# NEW YORK STATE DEPARTMENT OF ENVIRONMENTAL CONSERVATION

**Re: Supplemental Work Plan – SVI Corrective Measures, SSDS Expansion  
May 9, 2019  
General Circuits, Inc. Site #828085  
City of Rochester, Monroe County**

The New York State Departments of Environmental Conservation (NYSDEC) and Health (the Departments) have completed their review of the document entitled “*Supplemental Work Plan – SVI Corrective Measures, SSDS Expansion*” (the Work Plan), dated May 9, 2019 and prepared by Day Engineering, P.C. for the General Circuits, Inc. site in the City of Rochester, Monroe County. In accordance with 6 NYCRR Part 375-1.6, the Departments have determined that the Work Plan, with modifications and clarifications, substantially addresses the requirements of the Order on Consent. The modifications are outlined as follows:

**ATTACHMENT 1:  
REVISED FIGURE 1**

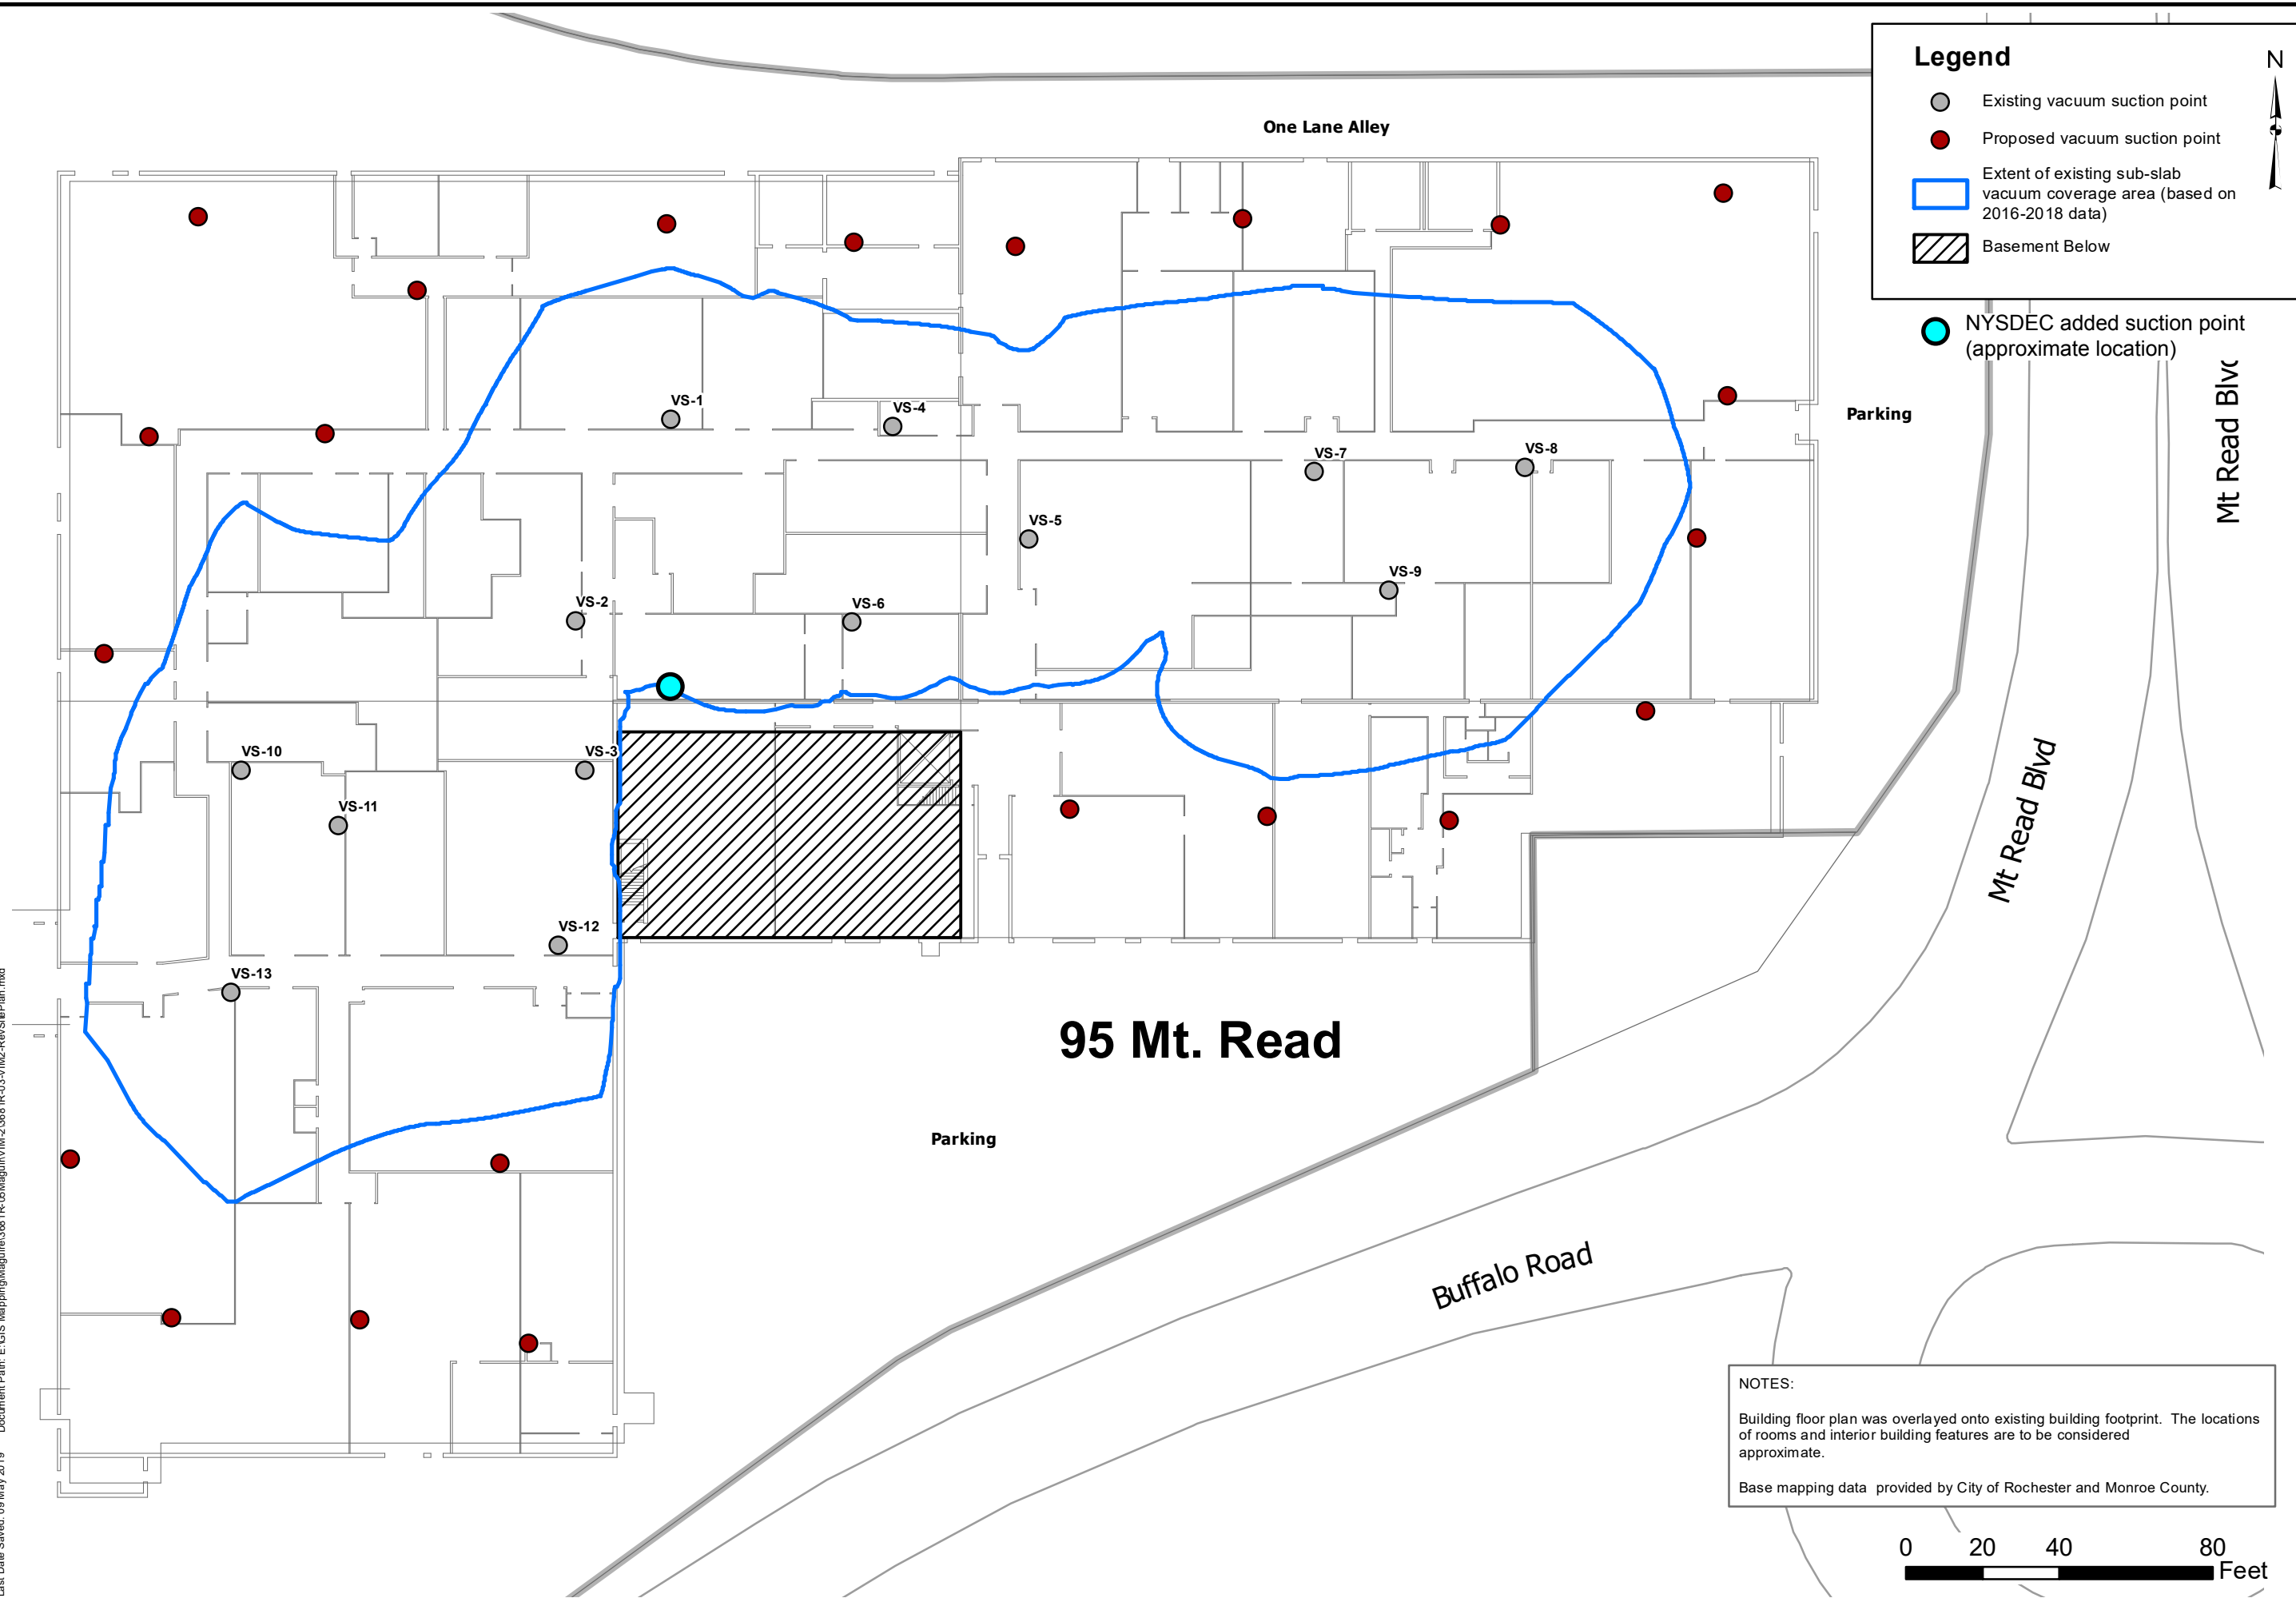
1. An additional SSDS extraction point will be located as shown on the revised Figure 1 (attachment 1). The added location addresses an area that had insufficient sub-slab vacuum in 2016 (see figure in attachment 2). Vacuum in this area was not re-measured after the most recent SSDS expansion. Alternatively, additional sub-slab vacuum readings can be collected from this area to determine if adequate vacuum has been achieved.
